## Submissions table – Draft Ōtūkaikino Stormwater Management Plan, June 2023

**Written Submission on Draft Ōtūkaikino Stormwater Management Plan**

- 1. Name of submitter:** Christchurch International Airport Limited (“CIAL”)
- 2.** This is a submission on the **Draft Ōtūkaikino Stormwater Management Plan (Draft OSMP) 2023.**

Figure 1: Proposed Tsunami Management Area (black hatching) within part of Woolston

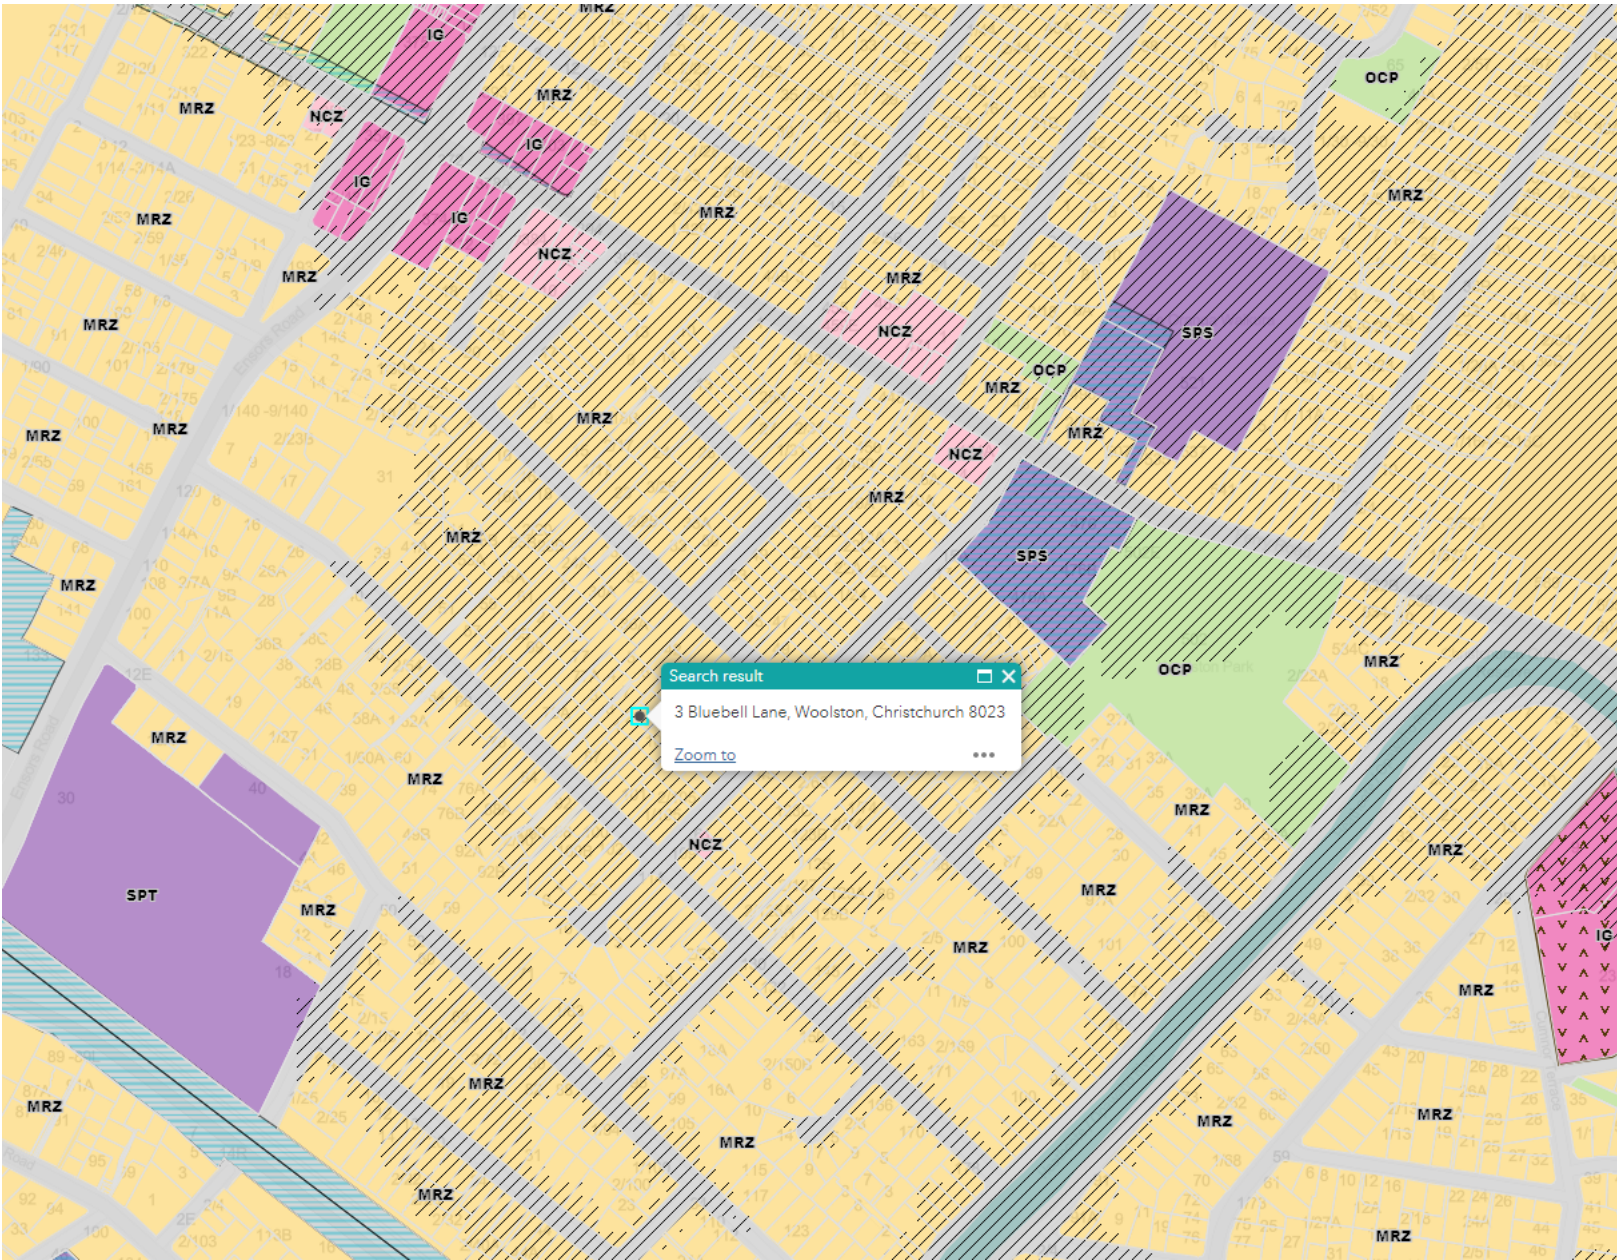
ID	Name - Organisation	Submitter feedback	Staff response to questions or concerns (if applicable)
		<p><b>Tsunami Risk</b>  Bluebell Lane is also inside a “Tsunami Management Area” It is irresponsible to allow infill housing in that same zone thus allowing new homes to be built in the path of a tsunami. Perhaps councillors and staff should lose their indemnity so they can be held personally liable for the consequences of poor planning decisions. The potential danger to existing homeowners could be exacerbated if increased housing density is allowed in a tsunami management area. Bluebell Lane and other Woolston residents must depend on council to protect our homes and communities from floods and tsunami. We also need our local communities to remain functionally connected and not disrupted by mass rental housing. I submit that Council is ignoring the plight of existing home owners who had liquefaction flood onto their properties from surrounding land following the 2010 and 2011 earthquakes. Council has also failed to address the issue of land that sank during the earthquakes and left existing home owners vulnerable to flooding from surrounding properties. Indeed Council has concealed the increased flooding vulnerability behind higher foundation requirements for new or rebuilt homes leaving existing homes increasingly vulnerable to flooding on foundations lower than Council considers safe from flooding.</p> <p><b>Lack of Council Communication</b>  Although council maps show our area as requiring new higher foundation levels Council has not contacted home owners to advise them of how existing homes might be protected from flooding or tsunami. Council has an obligation to clearly identify any flooding vulnerability to existing homes; and to mitigate the possibility of surrounding new homes on higher foundations and less permeable surrounding land channelling floodwater into lower lying areas. Residents on flood vulnerable land must be able to rely on Council to protect them. It is arguable that owners of houses sitting below safe floor levels should retreat, surely we have learnt that much post Cyclone Gabrielle. Combine our lower flooring levels with our homes being in a tsunami management area and the fact that ground water in Woolston is just below the surface, I am stunned that Council has not seen the need to, if not retreat from this area, at least restrict more housing. It is possible we may not need to retreat if any further infill development was restricted in this high risk area. Ignoring this issue and proposing increased housing density with higher foundations is irresponsible in the circumstances. I appreciate the work performed by Council post earthquakes to provide holding ponds to alleviate flooding but as Council’s own proposals indicate, new houses crammed together on impermeable land need to be built with higher foundations than we and other existing homes in this area have. It seems inevitable that we will be flooded when the waters rise. What existing residents need is much better drainage, less crammed in housing and more permeable surfaces if we are not to slip under future floodwaters. Existing home owners cannot do anything about their land having slumped but it would be a grave injustice if our homes were to be flooded because greater housing density contributed to water flooding into</p>

ID	Name - Organisation	Submitter feedback	Staff response to questions or concerns (if applicable)
		lower lying houses. Council has this one chance and the responsibility to protect residents from future disasters by identifying Bluebell Lane and other land that has sunk as a “Qualifying Matter” due to it being a “...High Flood Hazard Management Area [and] Flood Ponding Management Area...”. In addition to addressing existing drainage problems, the high water table, and ensuring the retention of adequate surrounding permeable land, Council needs to restrict housing density in Woolston around homes already experiencing increased flooding vulnerability.

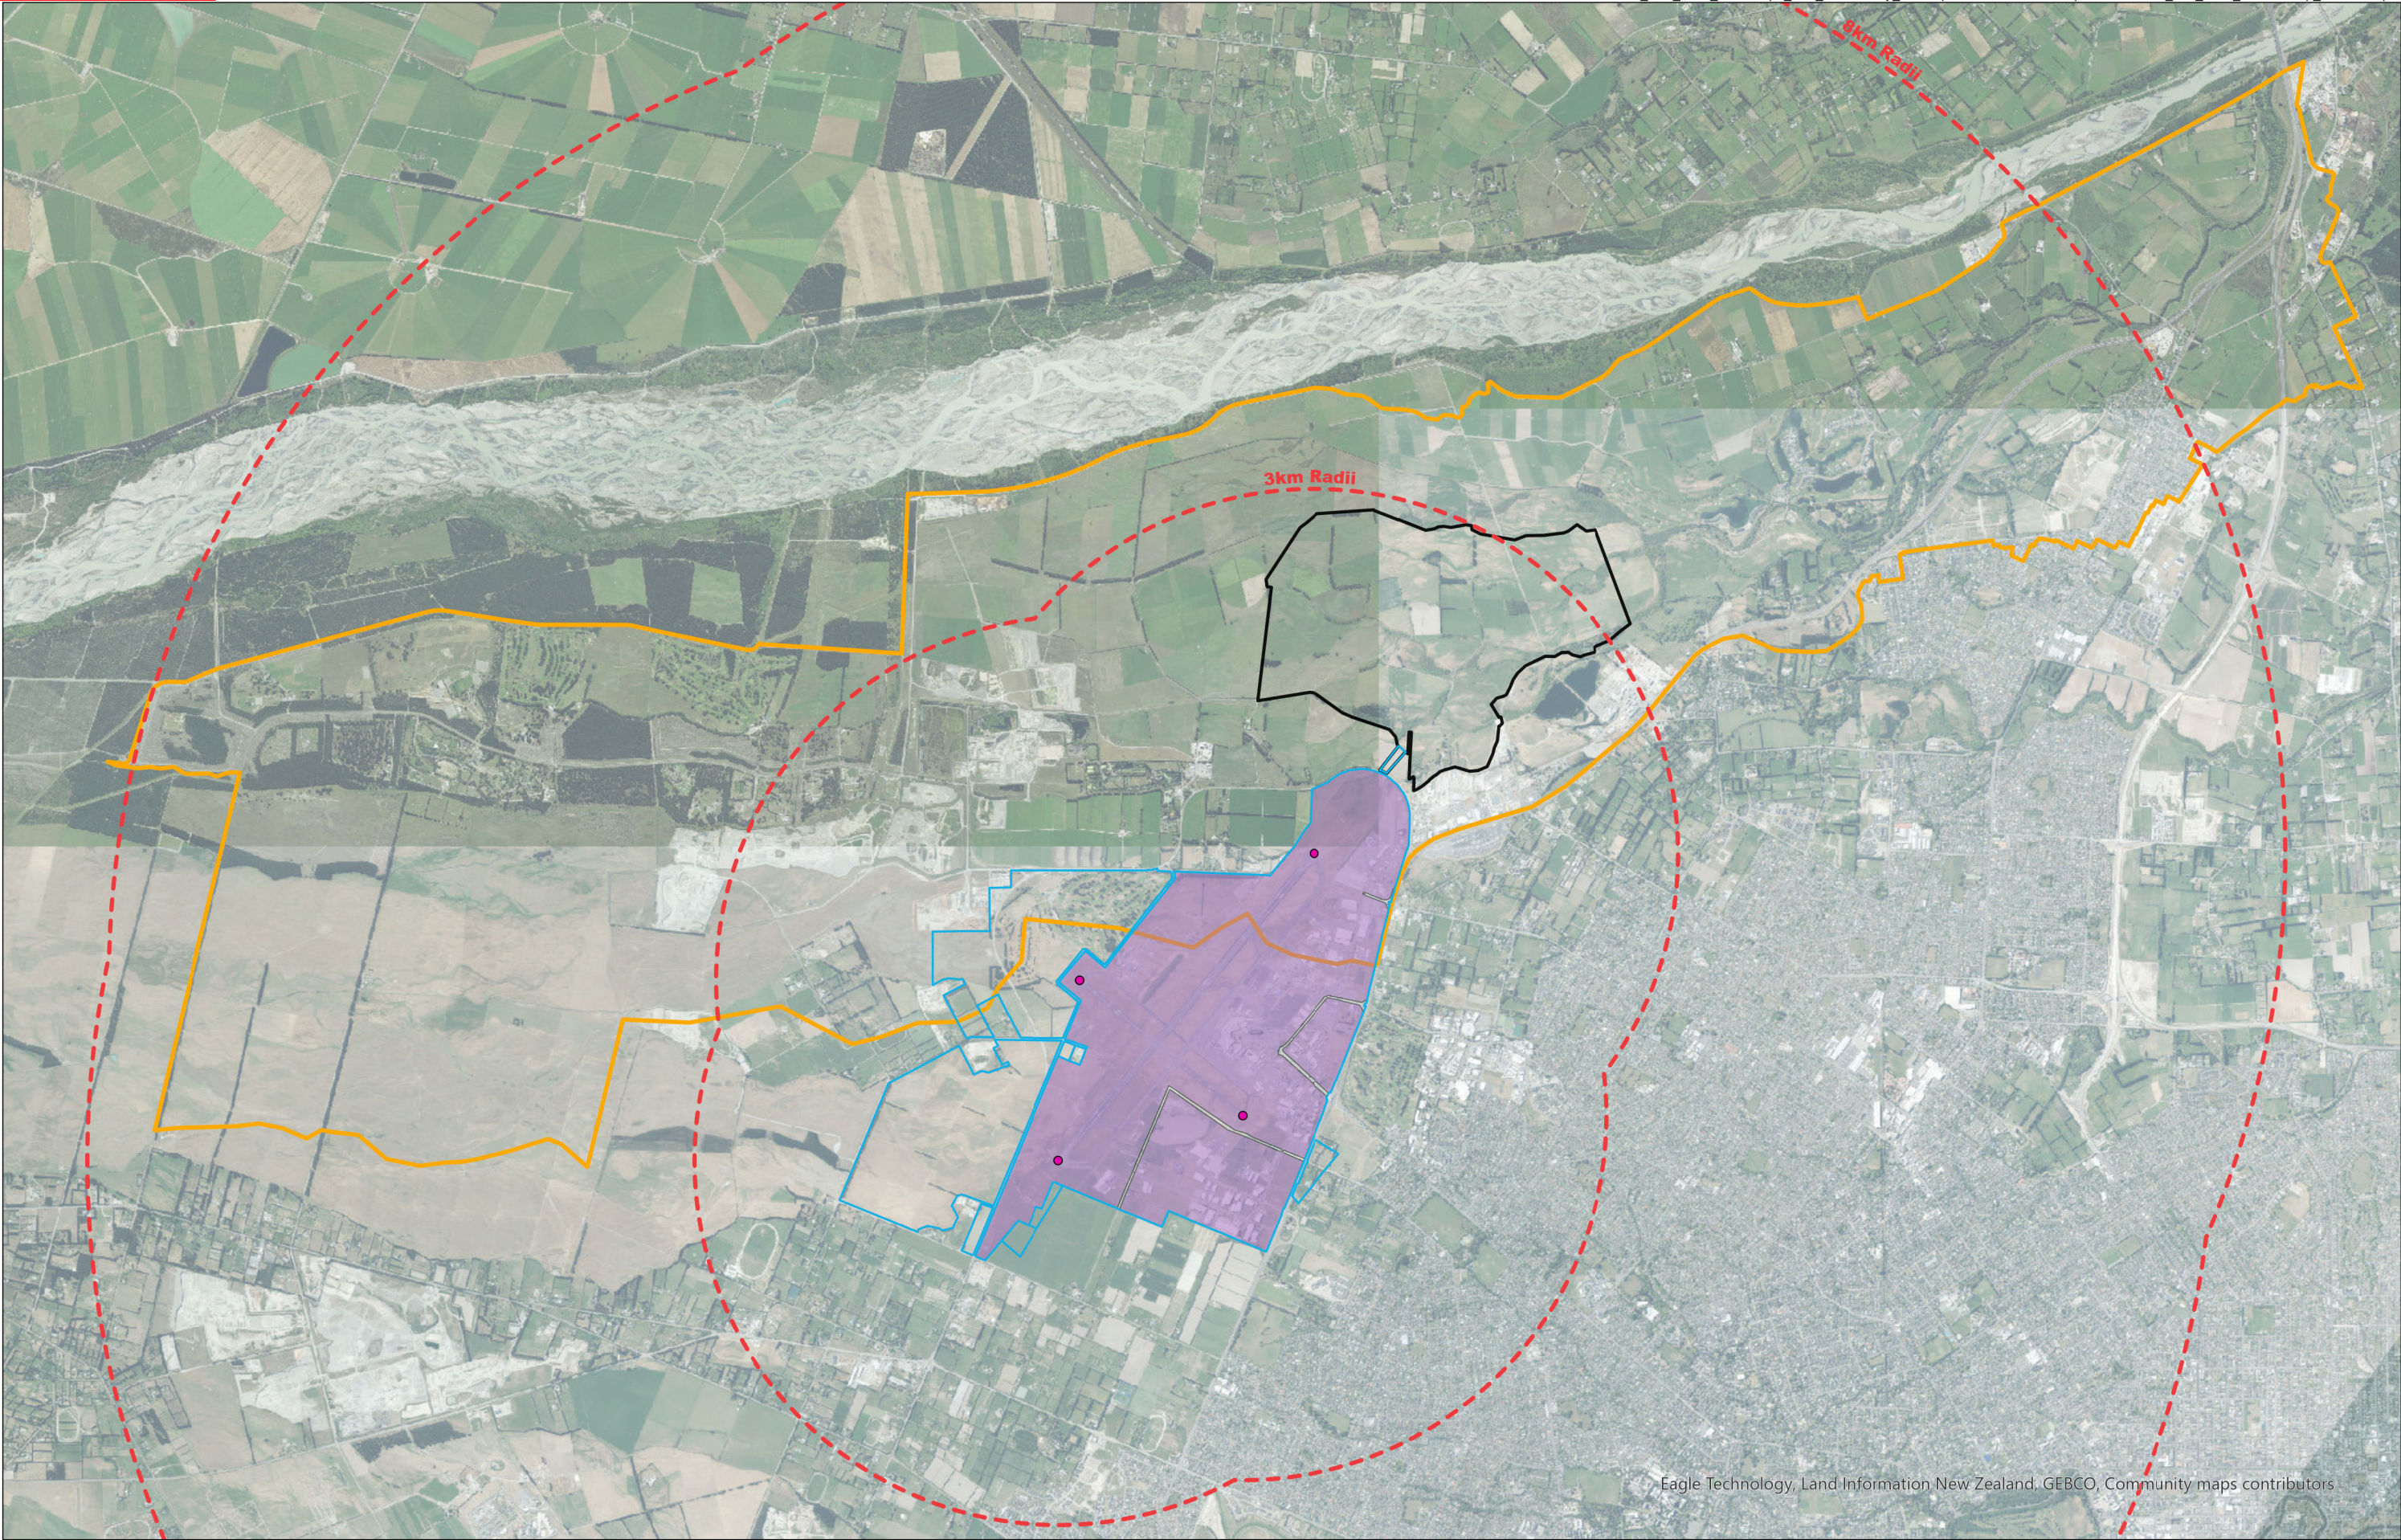
Chapter / provision	CIAL's reasons for submission	Relief sought
		<p><b><u>Figure X</u></b> [contained as Attachment 1 to this submission] <b><u>consult with CIAL</u></b>.</p> <p>[Note: Appendix G to be developed in conjunction with CCC].</p>
New objective	CIAL consider that the plan objectives do not give sufficient consideration to the issue of bird strike, nor the circumstances in which this may occur.	<p>Add a new Objective 5 as follows:</p> <p><b><u>'Our goals are</u></b></p> <ol style="list-style-type: none"> <li><b><u>1. To minimise the potential risk of bird strike to aircraft through consideration of the location and design of stormwater facilities.</u></b></li> <li><b><u>2. To collaborate with CIAL to ensure that (1) is achieved</u></b>.</li> </ol> <p>Add a new Action Plan for Bird Strike [included at the end of this submission – to be further developed in conjunction with CCC].</p> <p>Undertake consequential renumbering of objectives and any associated provisions.</p>

14 Conclusion	CIAL considers that recognition of bird strike should be made in the conclusion section of the document.	<p>Add an additional bullet point to the third paragraph as follows:</p> <ul style="list-style-type: none"> <li><b><u>'Reduce the threat of birdstrike through consideration of appropriate stormwater facility location and design</u></b>'.</li> </ul>
Appendices New Appendix G	CIAL request that guidance material on the location and design of stormwater facilities to reduce the potential for bird strike risks is	Add a new Appendix G titled <b><u>'Guidance Material Relating to Bird Strike</u></b> '.
